To: T10 Technical Committee
 From: Rob Elliott, HP (elliott@hp.com)
 Date: 4 November 2007
 Subject: 07-119r4 SAS-2 Far-end retimed loopback phy test function

Suggested changes to SAS-2

Figure 3 — SP (phy layer) state machine - transitions applicable to all states

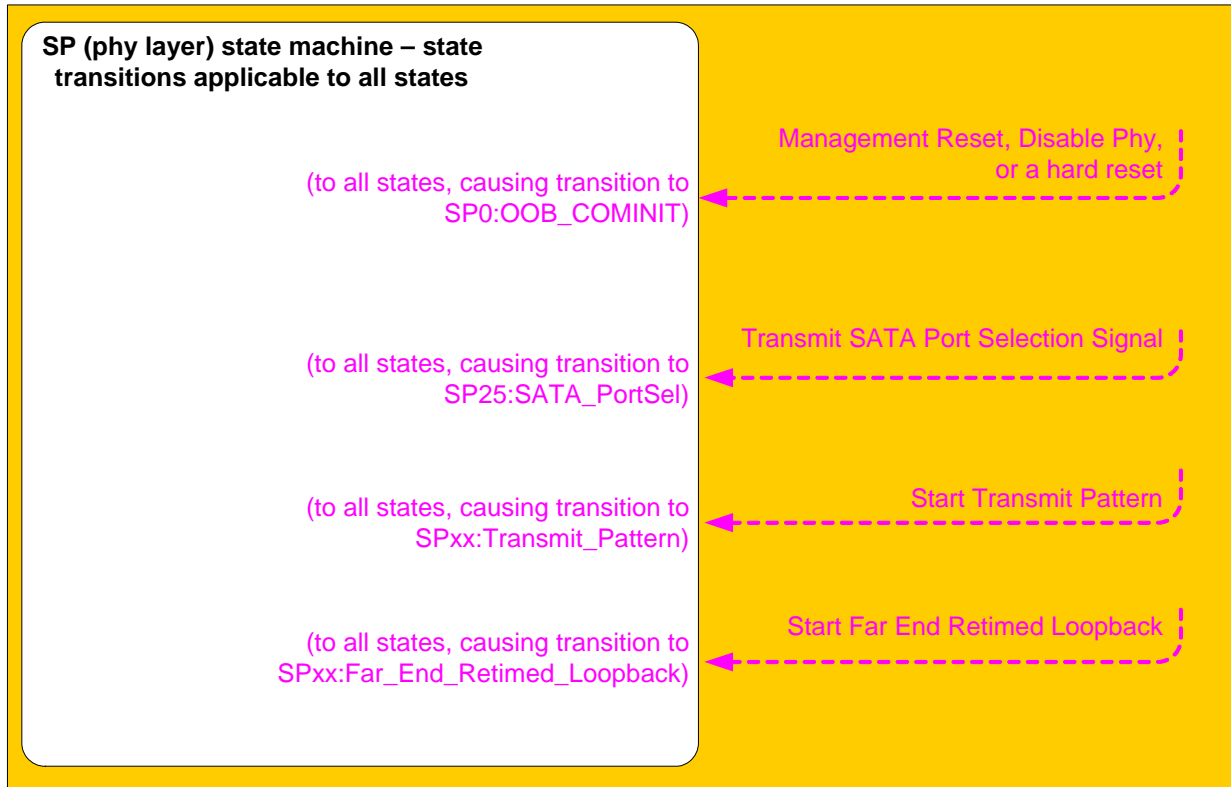
6.8.3.3 Transition to SPxx:Transmit_Pattern

This transition shall occur after receiving a Start Transmit Pattern request (e.g., from the SMP PHY TEST FUNCTION function requesting a phy test function of TRANSMIT_PATTERN in an expander device).

6.8.3.4 Transition to SPxy:Far_End_Retimed_Loopback

This transition shall occur after receiving a Start Far End Retimed Loopback request (e.g., from the SMP PHY TEST FUNCTION function requesting a phy test function of FAR_END_RETIMED_LOOPBACK in an expander device).

Figure 138 — SP (phy layer) state machine - OOB sequence states [modified]

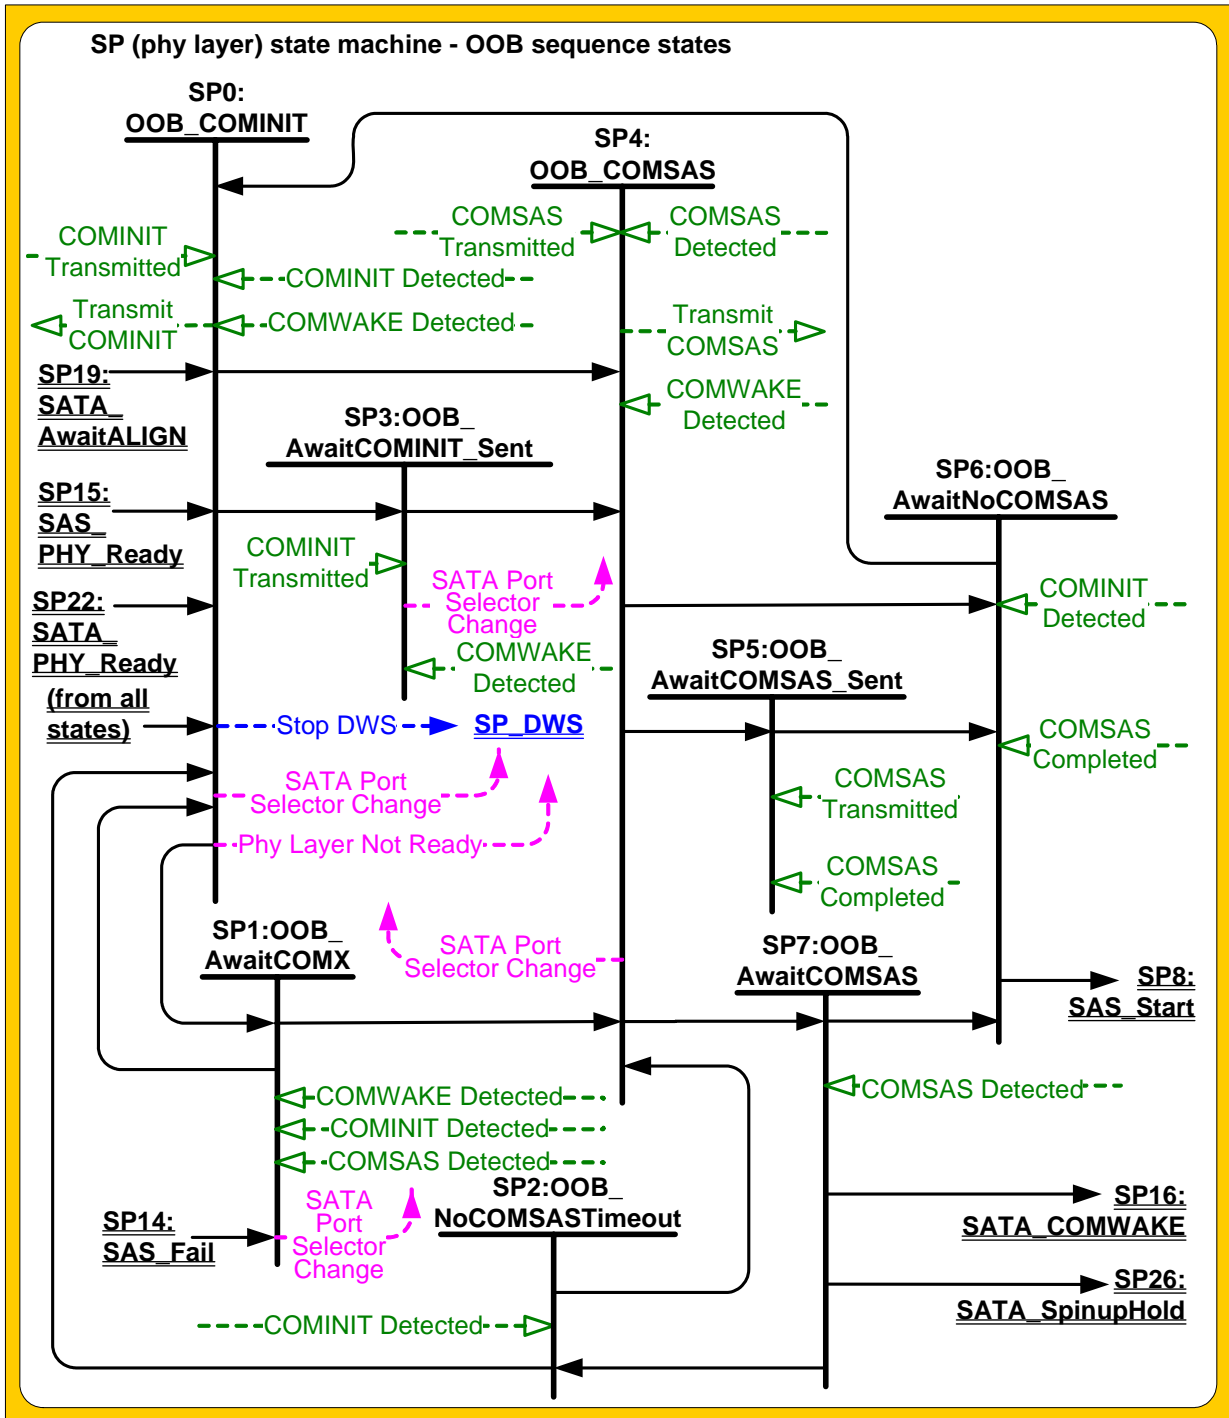
Figure 138 shows the OOB sequence states. These states are indicated by state names with a prefix of OOB.

Figure 139 — SP (phy layer) state machine - SAS speed negotiation states [modified]

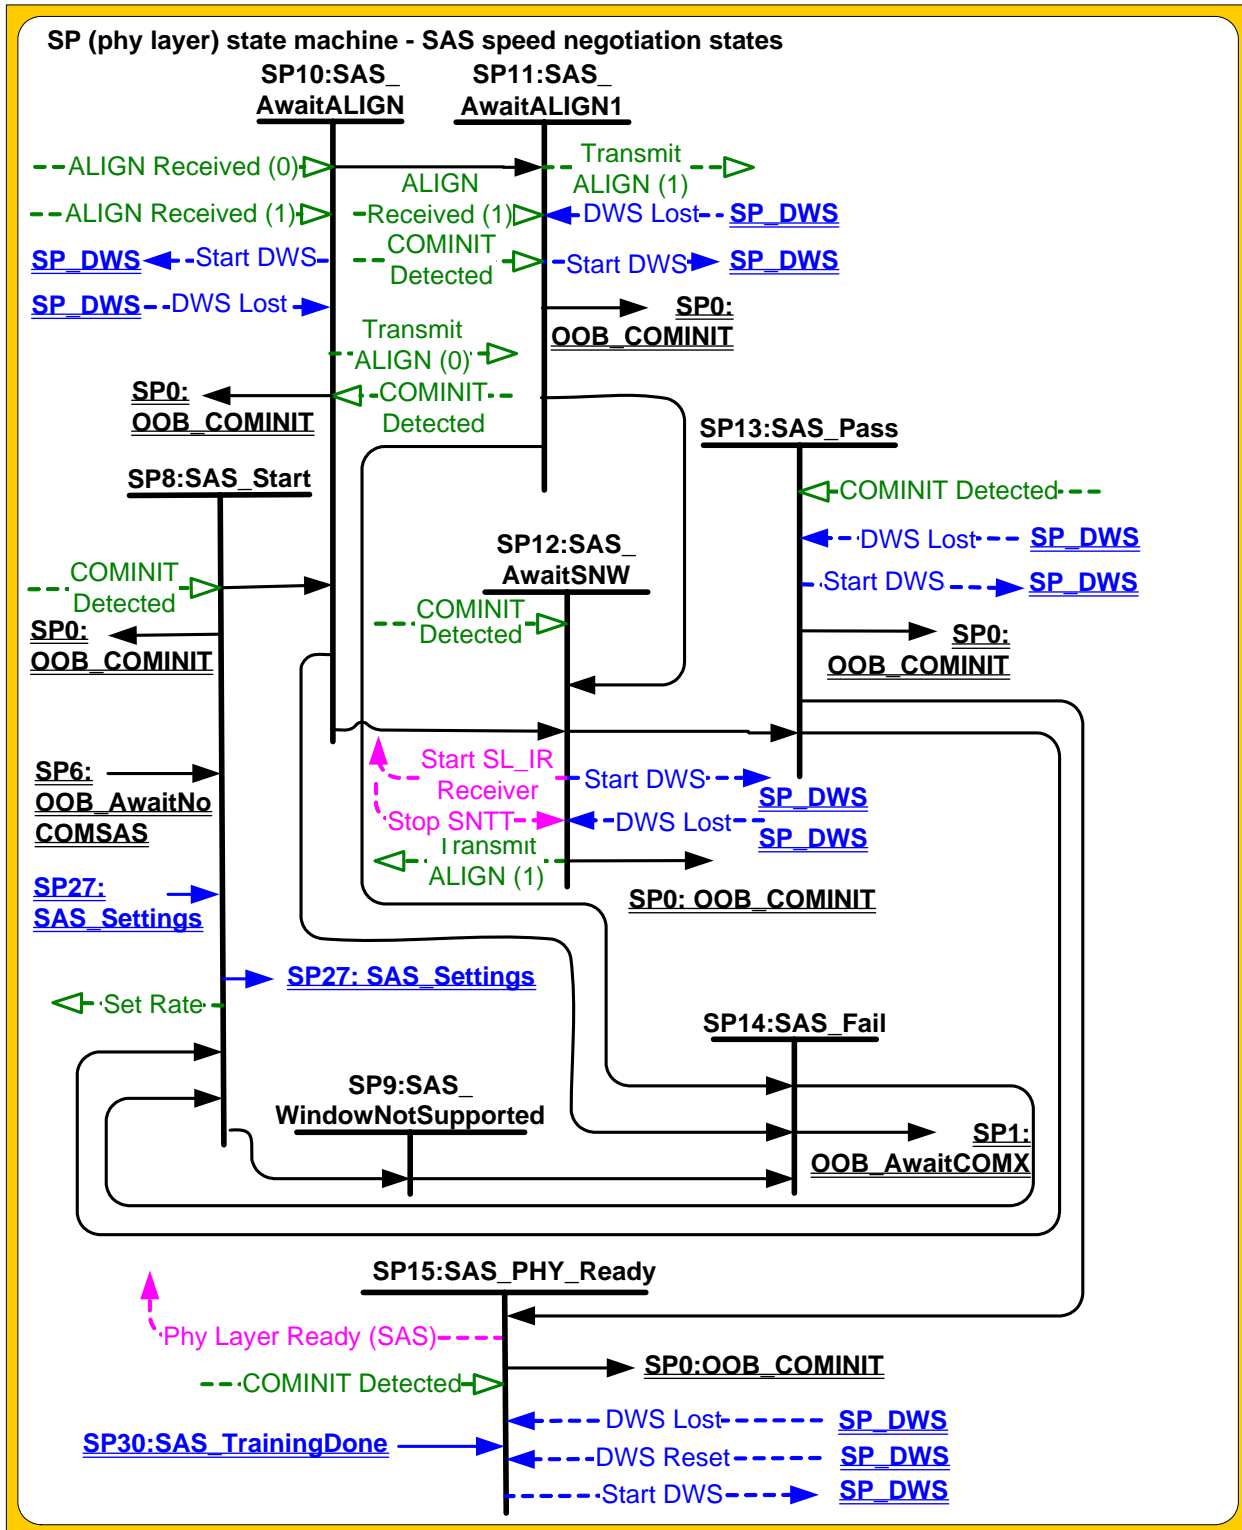
Figure 139 shows the SAS speed negotiation states, in which the phy has detected that it is attached to a SAS phy or expander phy rather than a SATA phy, and performs the SAS speed negotiation sequence. These states are indicated by state names with a prefix of SAS.

Figure 140 — SP (phy layer) state machine - SAS speed negotiation states for SNW-3 and Train-SNW [modified]

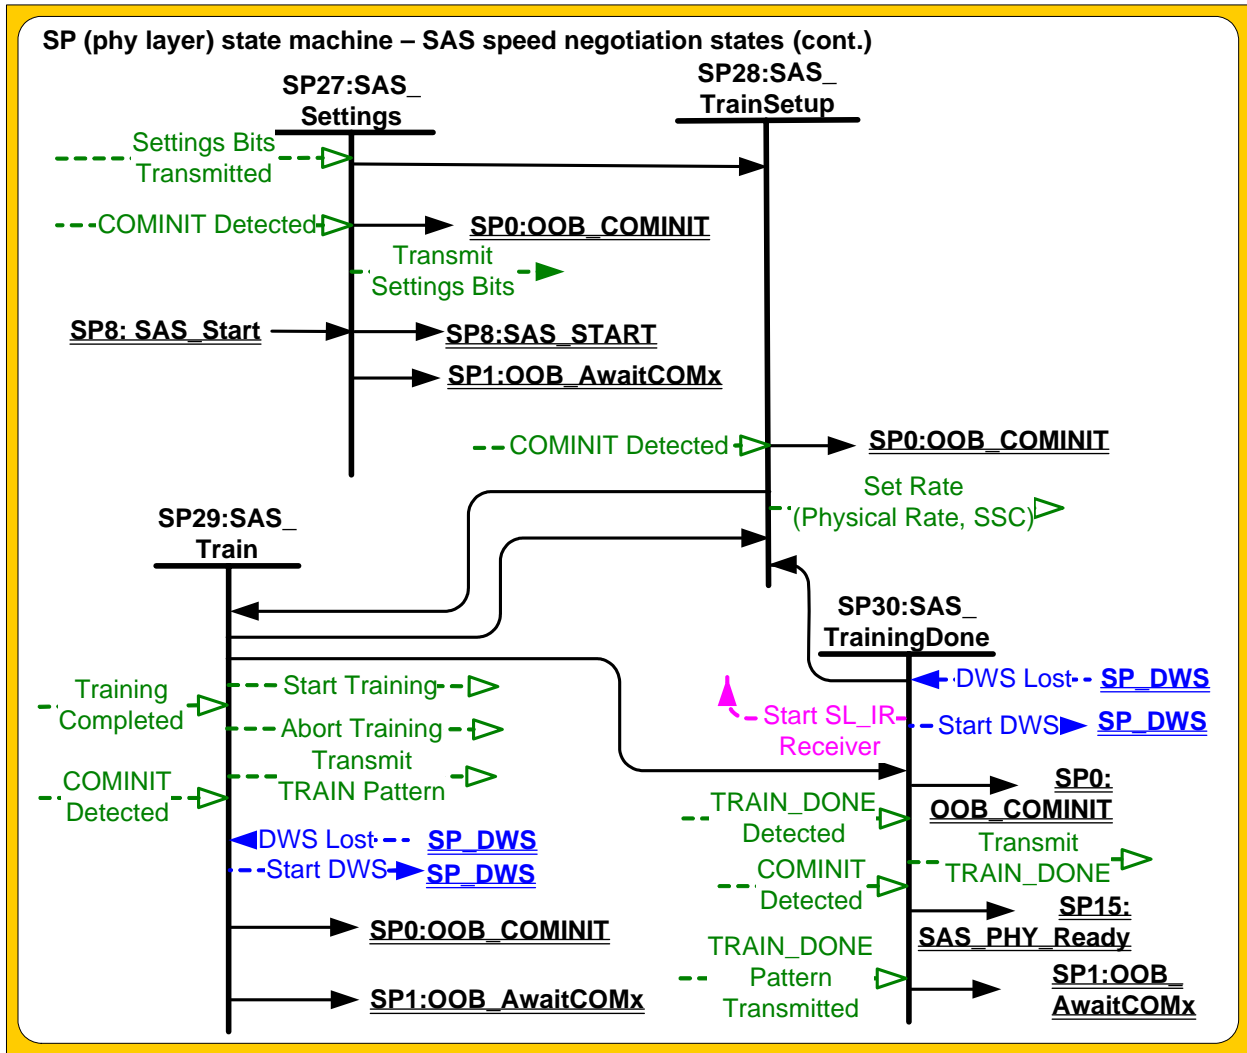
Figure 140 shows the SAS speed negotiation states related to SNW-3 and Train-SNW.

Figure 141 — SP (phy layer) state machine - SATA host emulation states [modified]

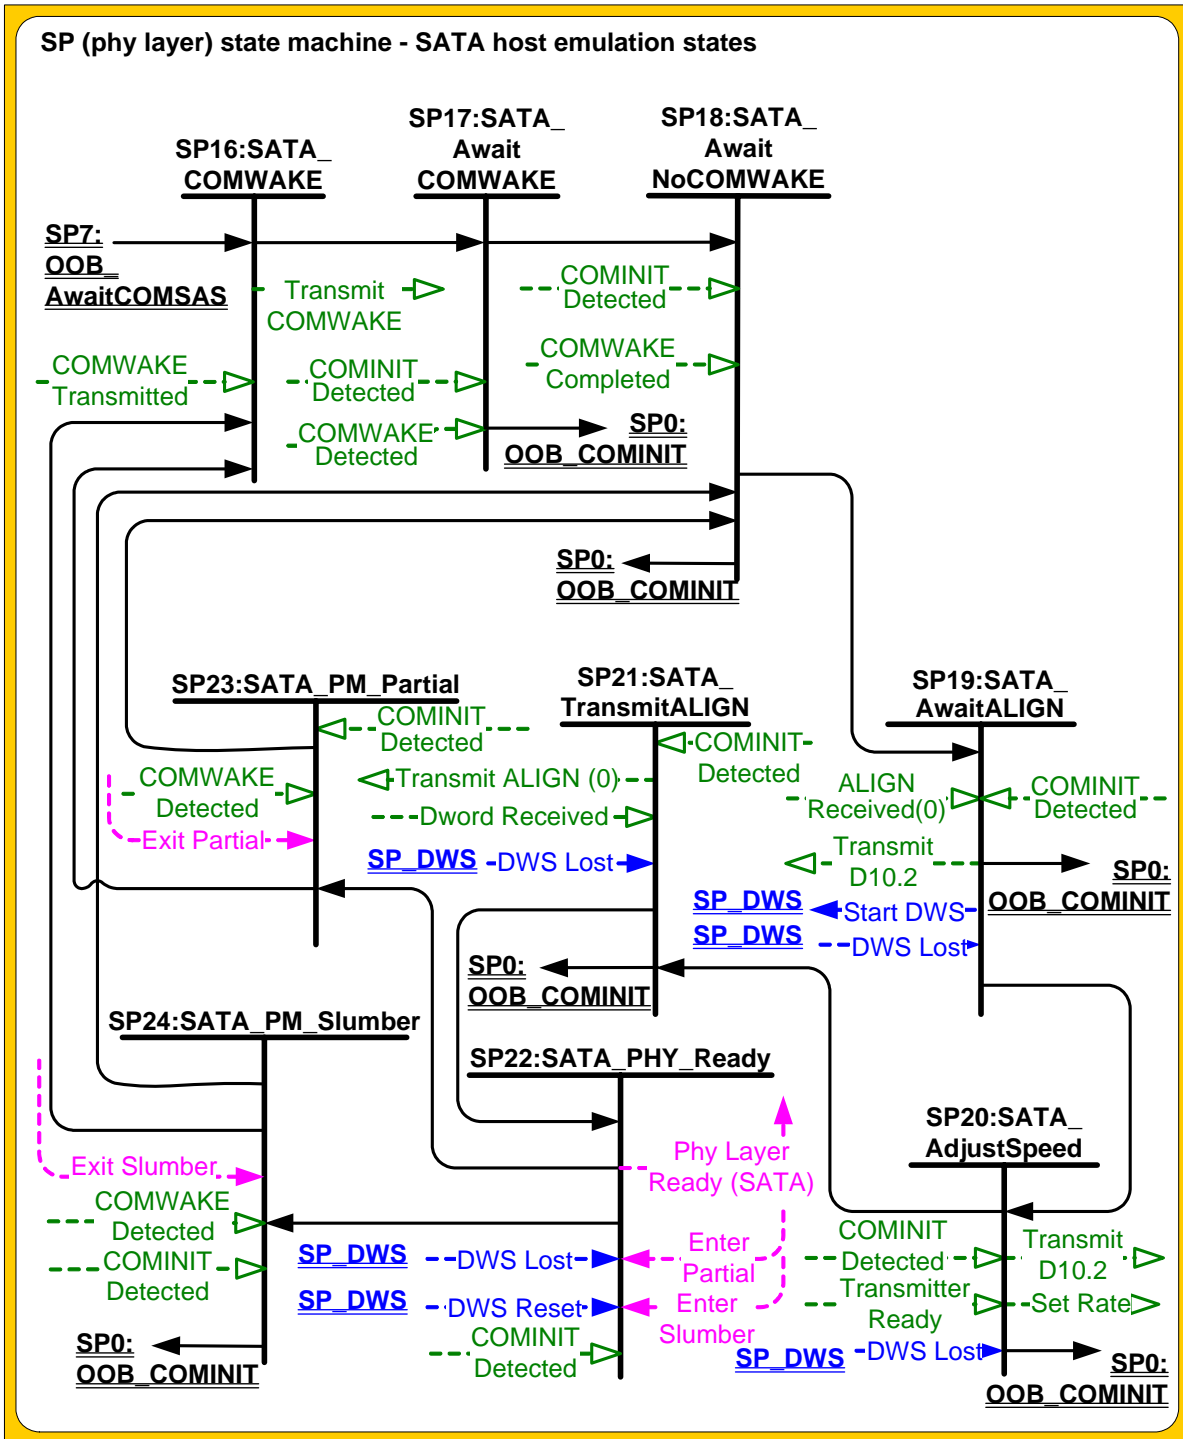
Figure 141 shows the SATA host emulation states, in which the phy has detected that it is attached to a SATA phy and behaves as if it were a SATA host phy, initiating the SATA speed negotiation sequence. These states are indicated by state names with a prefix of SATA.
